TO:	Mayor and Members City Council
DATE:	December 6, 2022
SUBJECT:	City Hall Pedestrian Access Walkway (Wishbone Structure) Repairs Communication Update (Ward 2) (EFFM22-02)
WARD(S) AFFECTED:	Ward 2
SUBMITTED BY:	Craig Murdoch Acting Director, Energy Fleet & Facilities Maintenance Public Works Department
SIGNATURE:

**RE: Structural review of Existing Concrete Entrance Structure at the rear of the Building Located at 71 Main St. W, Hamilton, ON
Our Project No. 2022-JPS-101**

Figure 1: Partly Damaged Column and Slab

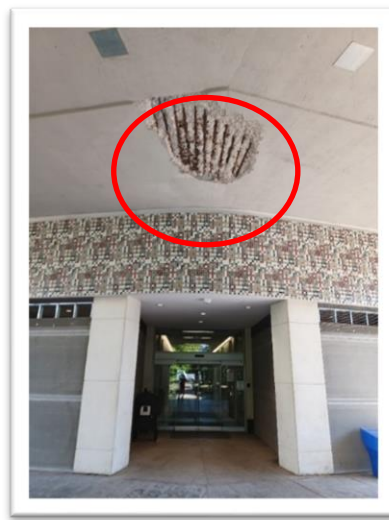
- The portion of the structural elements and areas identified in the attached drawings need to be repaired immediately as they may lead to a catastrophic structural damage and also are safety hazards.
- Barricades and adequate caution signage should be provided and not removed until concrete repairs identified in the drawings are undertaken.
- The deteriorated slab soffits are an immediate safety hazard and tenant/pedestrian access should be prohibited until repairs are completed.
- To prevent any catastrophic structural failures and to prevent injuries, it is our recommendation that concrete repairs should begin immediately in conjunction with the application of permit to perform the concrete repairs.
